Subject: FW: F/24/97885 - Places for Leisure Eastleigh - construction of four outdoor floodlit padel courts - Revised plans - landscape comments

Subject: F/24/97885 - Places for Leisure Eastleigh - construction of four outdoor floodlit padel courts - Revised plans - landscape comments

Subject: F/24/97885 - Places for Leisure Eastleigh - construction of four outdoor floodlit padel courts

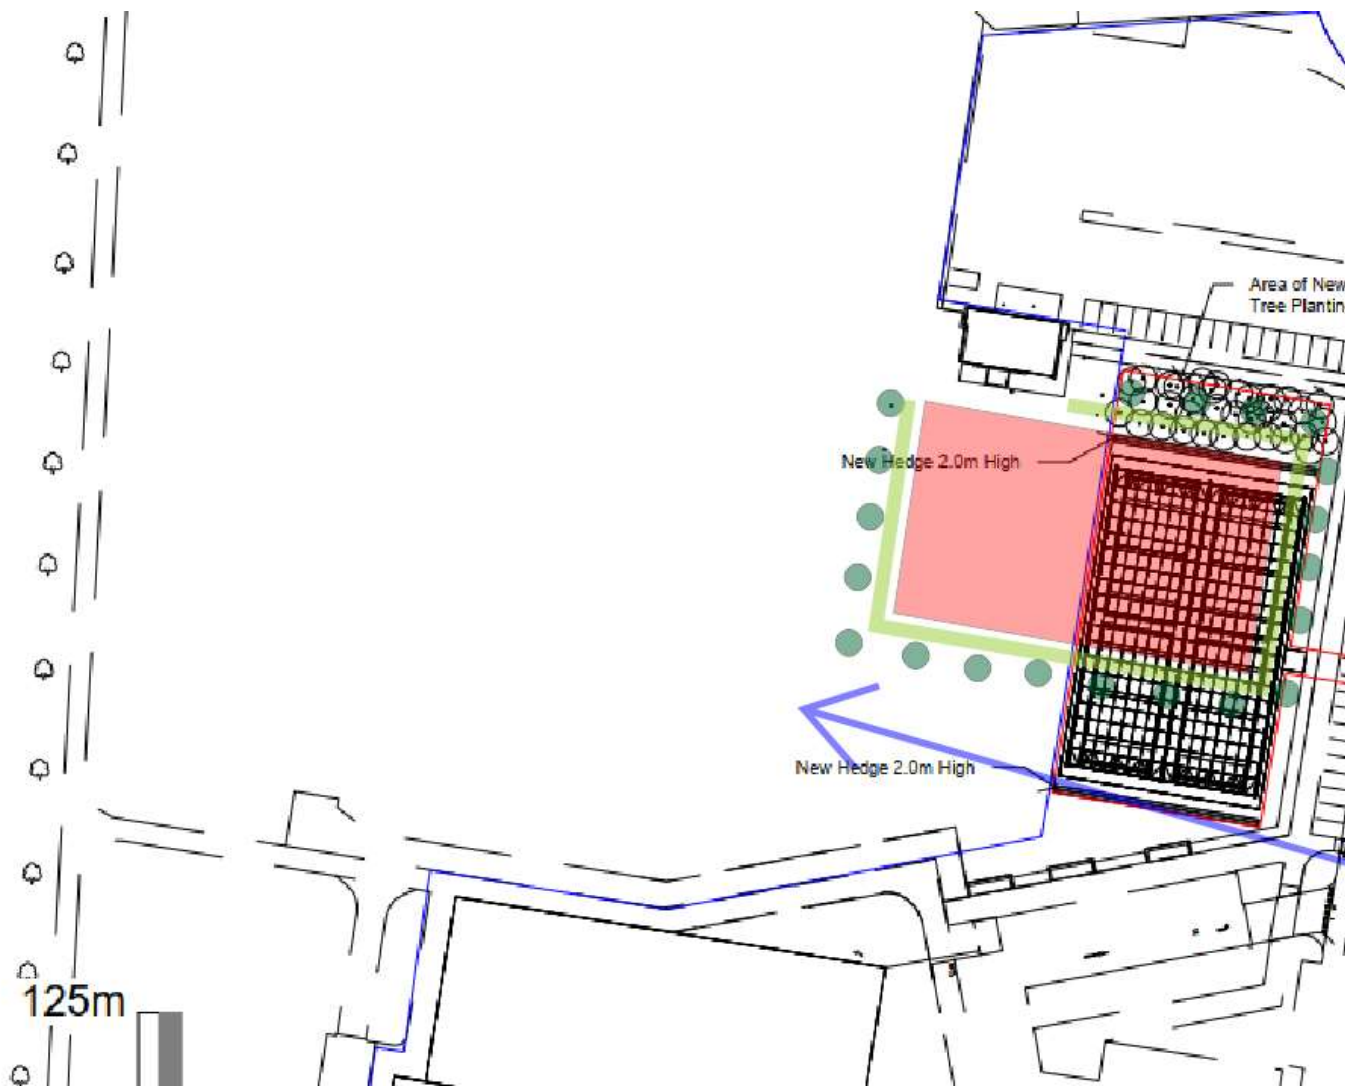
a/ Having read through the Planning Statement I could not find any detailed landscape assessment underpinning the proposed location and orientation of the padel courts. The courts, canopy and enclosing glazed/mesh panels represent a significant new structure (max. 9.5m high) that will be immediately apparent in the scene. Since this is the case, at least a basic assessment of key views would be helpful.

This may result in other location/orientation options for the facility. For example, should the courts be re-located/re-orientated to allow some views from the parking area across the playing fields and open space (see sketch mark up below for rough idea):

A layout similar to this would create space for tree planting to soften views from the main sport centre.
